**A. 10-06-007 South Bay Substation Relocation Project PTC  
Energy Division Data Request 4, Dated February 1, 2011  
SDGE-ED-004: Q 1-3  
SDG&E 2/8/11 Response**

**Question #1**

PEA Figures – Please incorporate the revised site plan on the following figures from the PEA and provide:

**FIGURE 4.1-6**  
**PRELIMINARY LANDSCAPE CONCEPT**  
 SDG&E South Bay Substation Relocation

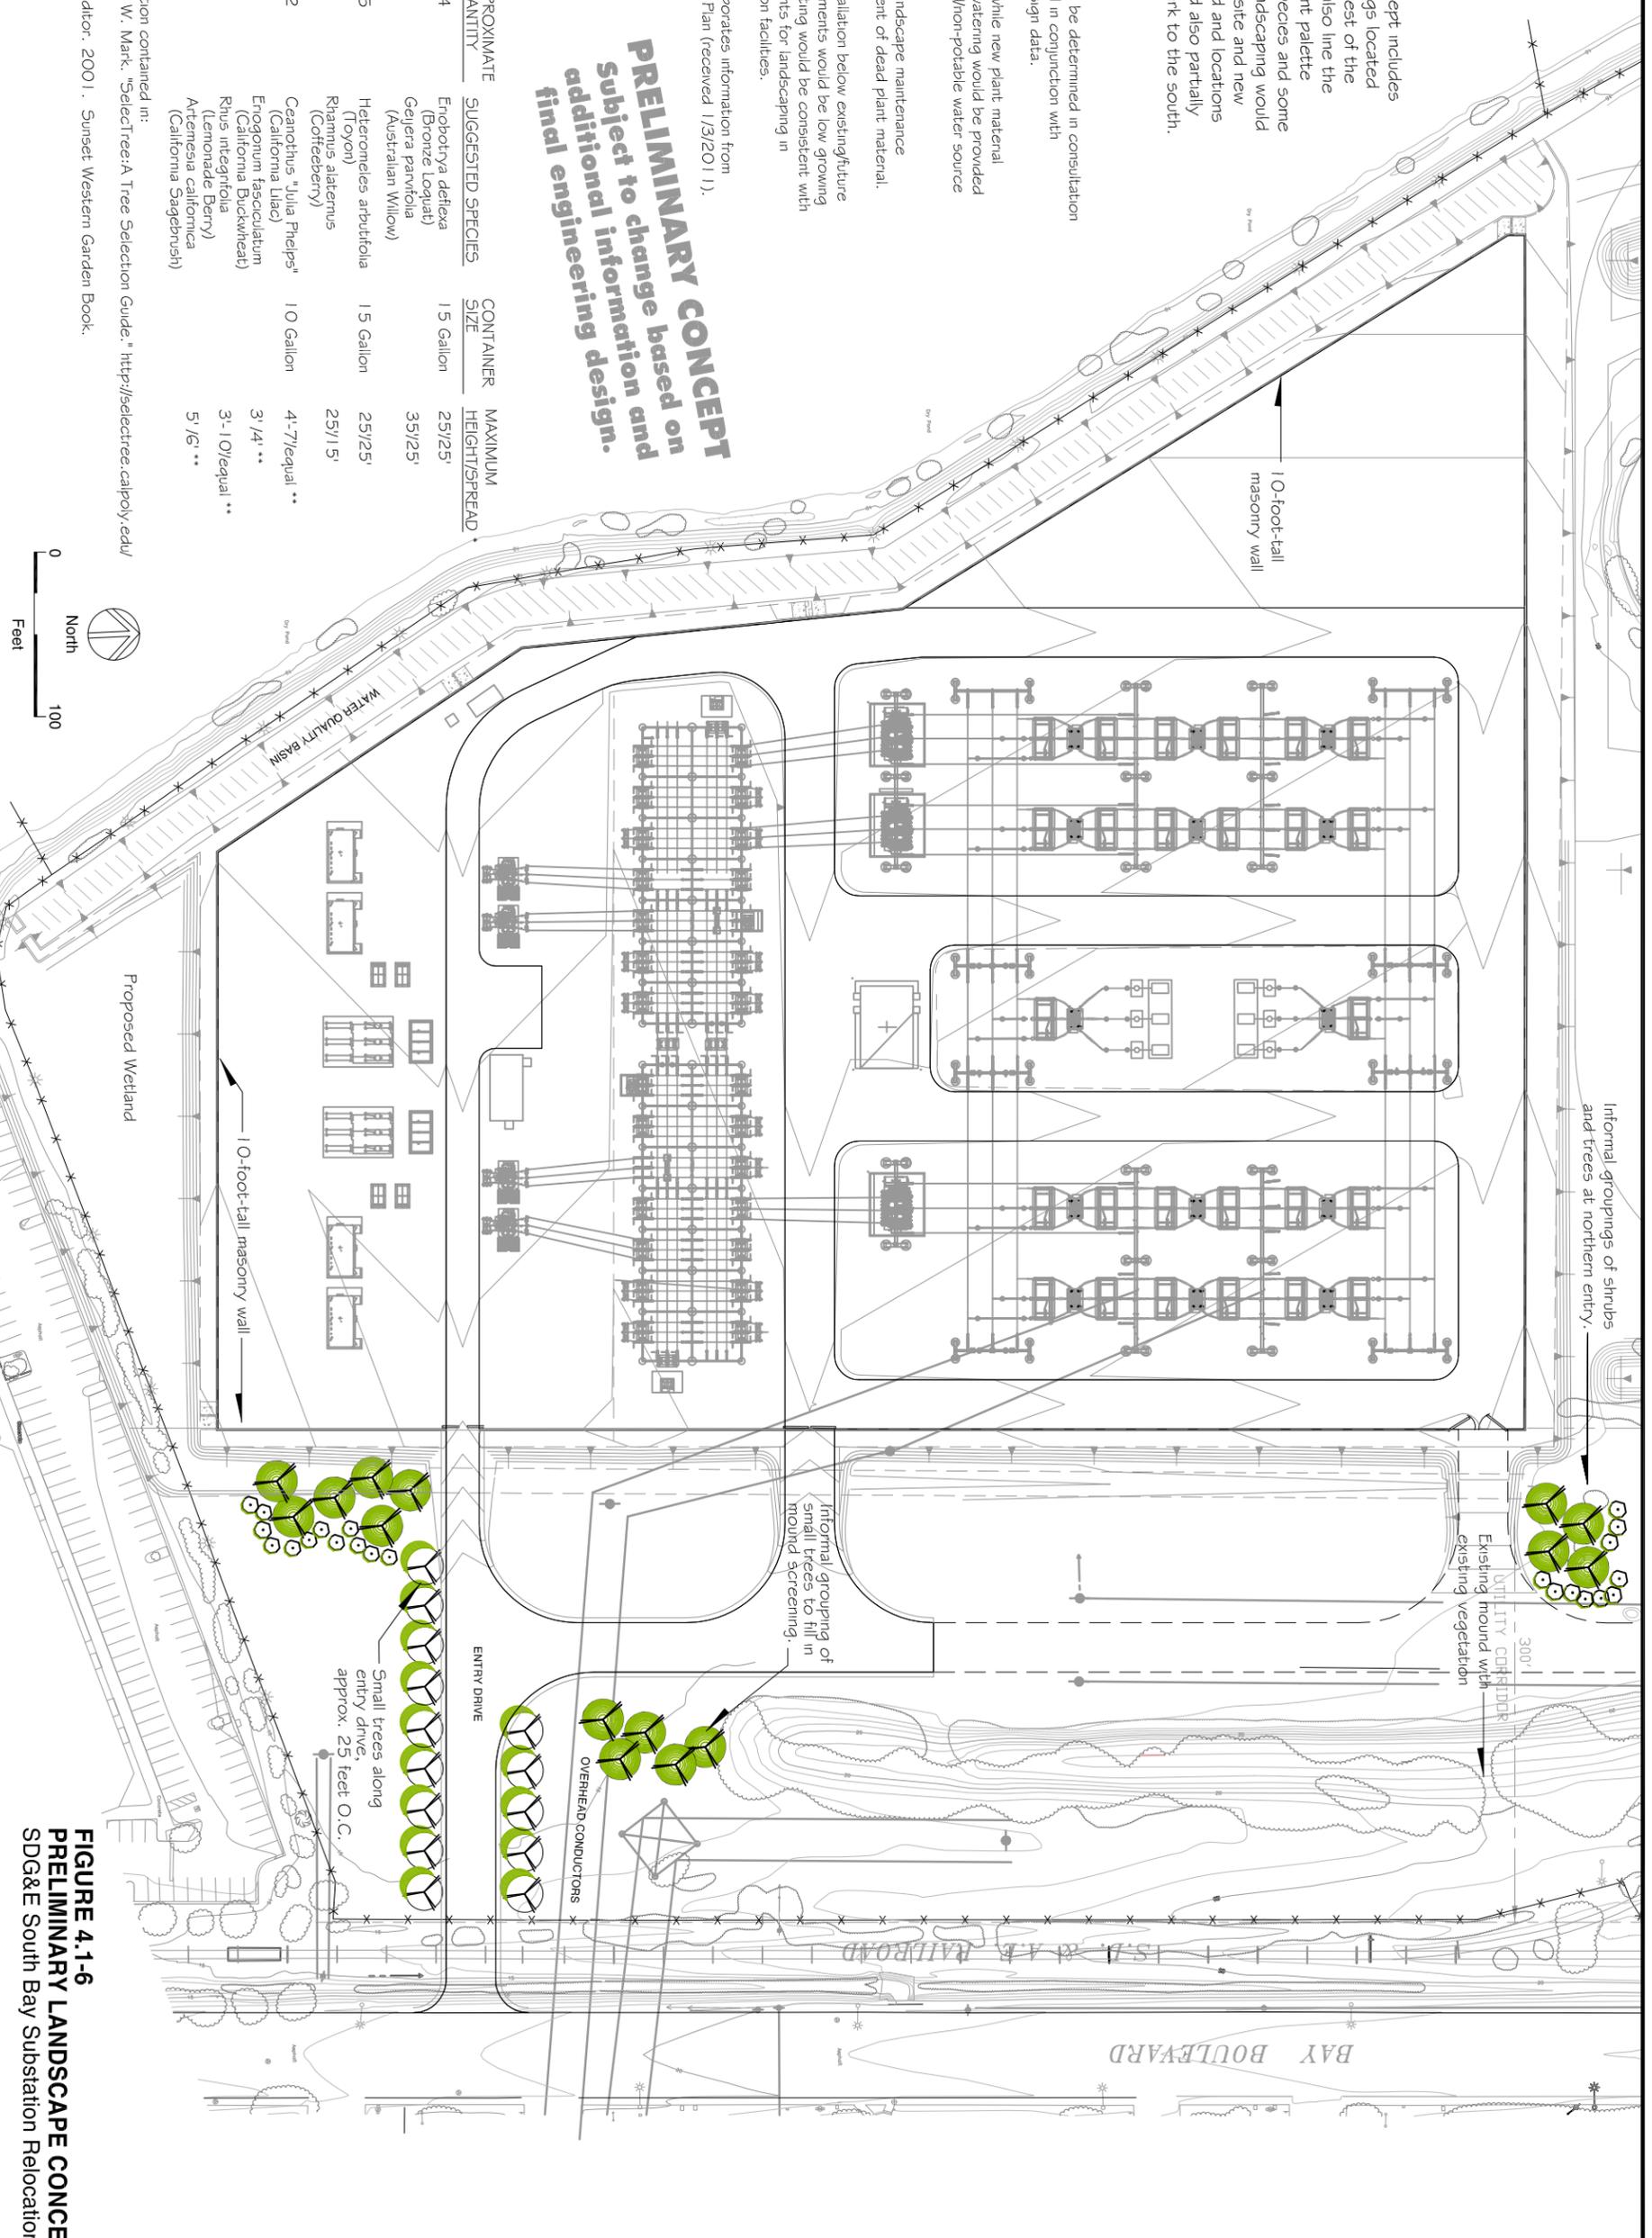
- a. Figure 3-7: Bay Boulevard Substation Temporary and Permanent Impact Area (please provide the ARC GIS files associated with this updated figure)
- b. Figure 4.1-6: Preliminary Landscape Concept
- c. Figure 4.10-3: Bay Boulevard Substation Operational Noise Contours

- a. Figure 3-7: Bay Boulevard Substation Temporary and Permanent Impact Area has been revised to reflect SDG&E's new grading plan for the Proposed Project and has been uploaded to Dudek's FTP site.
- b. Figure 4.1-6: Preliminary Landscape Concept has been revised to reflect SDG&E's new grading plan for the Proposed Project and has been uploaded to Dudek's FTP site.
- c. Figure 4.10-3: Bay Boulevard Substation Operational Noise Contours has been revised to reflect SDG&E's new grading plan for the Proposed Project and has been uploaded to Dudek's FTP site.
